ASX/U-51

SYSTEST TESTUTL ATLworks

UPDATE NOTICE

REV 6.00B

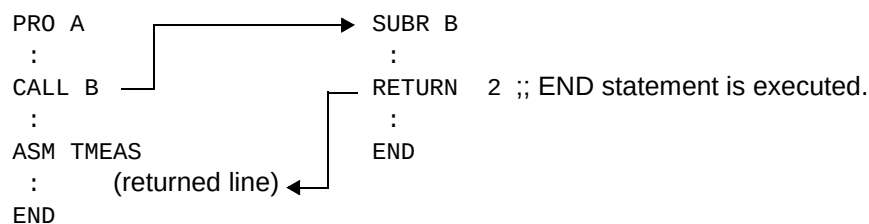
Case 1: The offset value for RETURN v was positive and the ASM TMEAS or ASM VMEAS was written between the CALL statement and the returned line.

Improved ➡ This problem has been fixed. The program execution is now returned to the line specified in the RETURN statement.

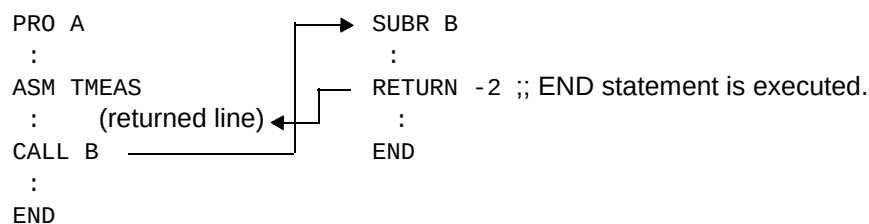
Case 2: The offset value for the RETURN v was negative and the ASM TMEAS or ASM VMEAS was written between the beginning of the program that called the external program and the returned line.
